ACCESSION NBR: 9612260086 DOC. DATE: 96/12/18 NOTARIZED: YES DOCKET #  
 FACIL: 50-261 H.B. Robinson Plant, Unit 2, Carolina Power & Light C 05000261  
 AUTH. NAME AUTHOR AFFILIATION  
 CHERNOFF, H.K. Carolina Power & Light Co.  
 RECIP. NAME RECIPIENT AFFILIATION  
 Document Control Branch (Document Control Desk)

SUBJECT: Forwards missing pages of 960827 TS submittal requesting TS  
 change conversion to improved STS consistent w/NUREG-1431,  
 "STS Westinghouse Plants," Rev 1.

H. B. ROBINSON STEAM ELECTRIC PLANT, UNIT NO. 2  
DOCKET NO. 50-261/LICENSE NO. DPR-23  
REQUEST FOR TECHNICAL SPECIFICATIONS CHANGE  
CONVERSION TO IMPROVED STANDARD TECHNICAL  
SPECIFICATIONS CONSISTENT WITH NUREG-1431, "STANDARD  
TECHNICAL SPECIFICATIONS-WESTINGHOUSE PLANTS," REVISION 1  
ERRATA

Figure 2.1.1-1 (page 1 of 1)  
Reactor Core Safety limits

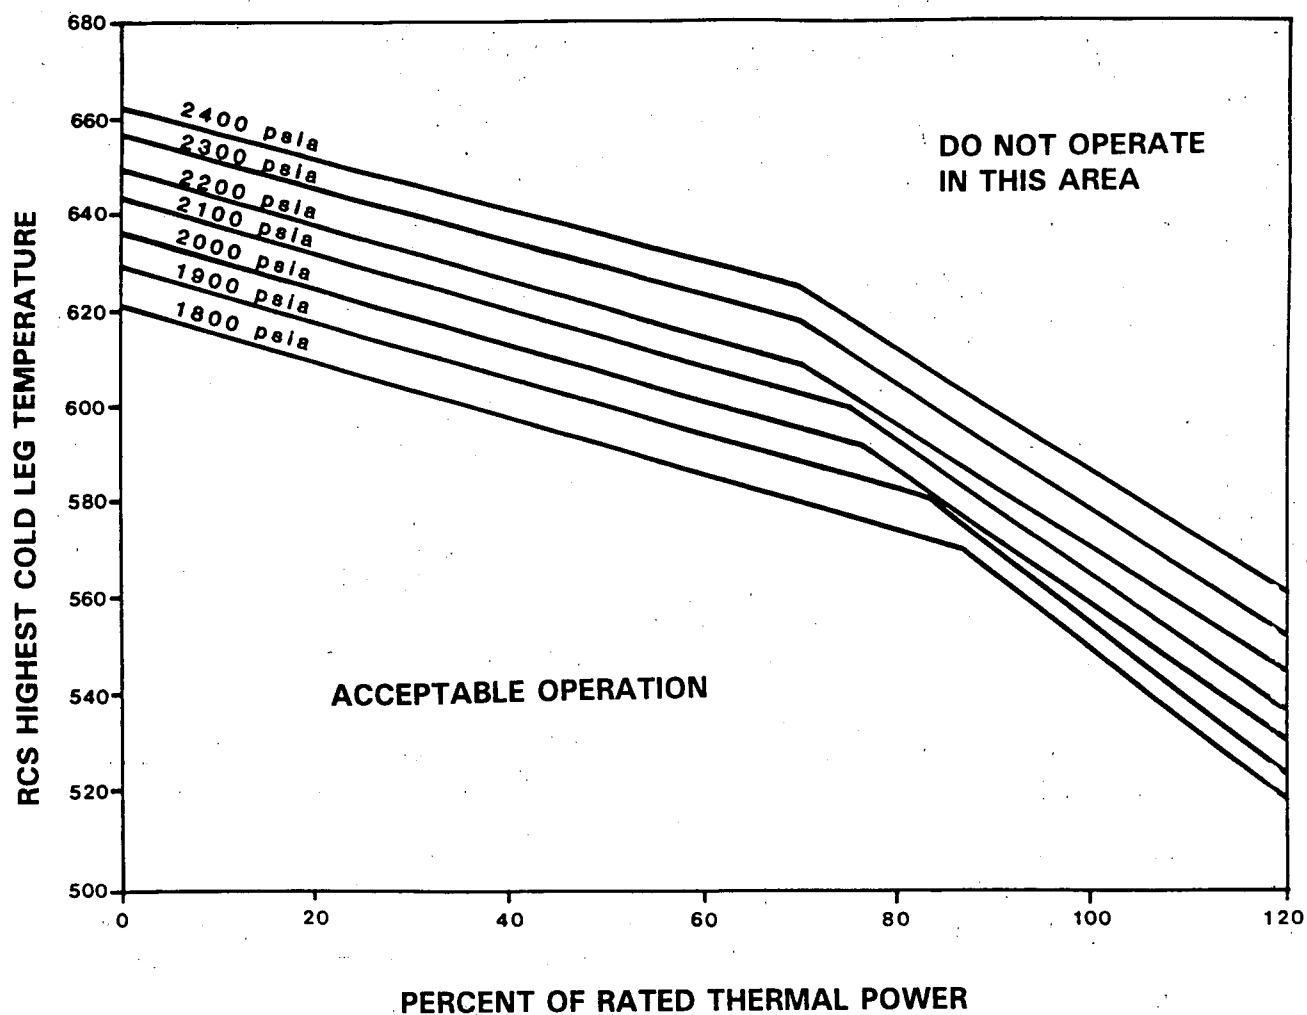
In MODES 1 and 2, the combination of THERMAL POWER, Reactor Coolant System (RCS) highest cold leg temperature, and pressurizer pressure shall not exceed the SLs specified in Figure 2.1.1-1.
